Access Compliance Report Public Rights-of-Way (Curb Ramps)

Main Street: WHITNEY_DR Cross Street: WHEELER_PL Location: NW

ADA ID: RPAT211001112135 Ramp Type: Type 1 - Perpendicular Diagonal Initial Pass/Fail: Fail Overall Compliance: No Severity Score: 0

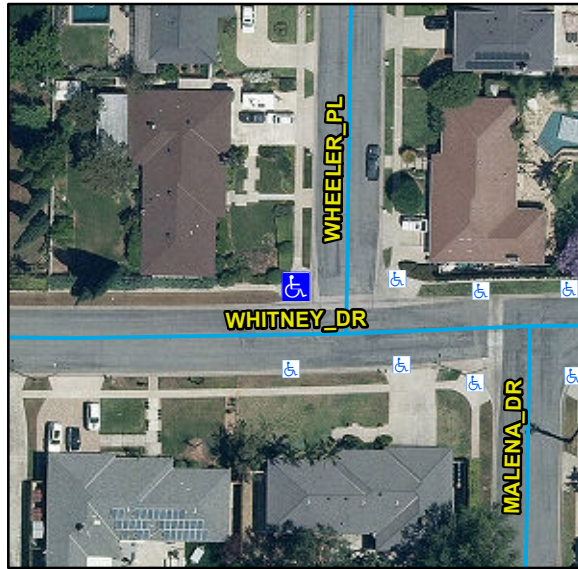
Compliance	Description	Data	Compliance	Description	Data
N/A	Ramp Length (in)	108	N/A	Flare Type LT	
Yes	Ramp Width (in)	56			N/A
Yes	Ramp Run Slope (%)	7.5	N/A	Flare Slope LT (%)	N/A
Yes	Ramp Cross Slope (%)	3.3	N/A	Flare Traversable LT	N/A
N/A	Landing Present	N/A	N/A	Flare Type RT	
N/A	Landing Length (in)	N/A			N/A
N/A	Landing Width (in)	N/A	N/A	Flare Slope RT (%)	N/A
N/A	Landing Run Slope (%)	N/A	N/A	Flare Traversable RT	N/A
N/A	Landing Cross Slope (%)	N/A	N/A	DWS Provided	N/A
N/A	Landing Movement Obstructed?	N/A	N/A	DWS Contrast	N/A
	Landing Movement Type	N/A	N/A	DWS Length (in)	N/A
N/A	Landing Shared	N/A	N/A	DWS Full Width	N/A
N/A	Clear Space	Yes	N/A	DWS Offset Left (in)	N/A
N/A	Clear Space To Crosswalk (in)	N/A	N/A	DWS Offset Right (in)	N/A
N/A	Marked Crosswalk 1	No	N/A	Marked Crosswalk 2	No
	Crossing 1 Direction	S		Crossing 2 Direction	E
	Marked Crosswalk 1 Width (in)	N/A		Marked Crosswalk 2 Width (in)	N/A

N/A	Ramp Inside Crosswalk 1	N/A	Yes	Ramp Inside Crosswalk 2	N/A
	Crossing 1 Slope (%)	4.1		Crossing 2 Slope (%)	0.1
	Crossing 1 Cross Slope (%)	0.2		Crossing 2 Cross Slope (%)	6
N/A	Gutter Ponding	N/A	No	Curb Slope	9.4
Yes	Gutter Lip Height (in)	0		Road Run Slope (%)	3.7
N/A	Gutter Run Slope (%)	N/A		Road Cross Slope (%)	6.7
N/A	Gutter Cross Slope (%)	N/A			
Yes	Overall Surface Condition: Acceptable		Yes	Perp Joint Present	Yes
	Cross Gutter Present?	Yes		Spandrel Present?	Yes
	Replace Cross Gutter?	No		Replace Spandrel?	No

Remove & Replace Curb Ramp With Two New Directional Ramps or Equivalent.
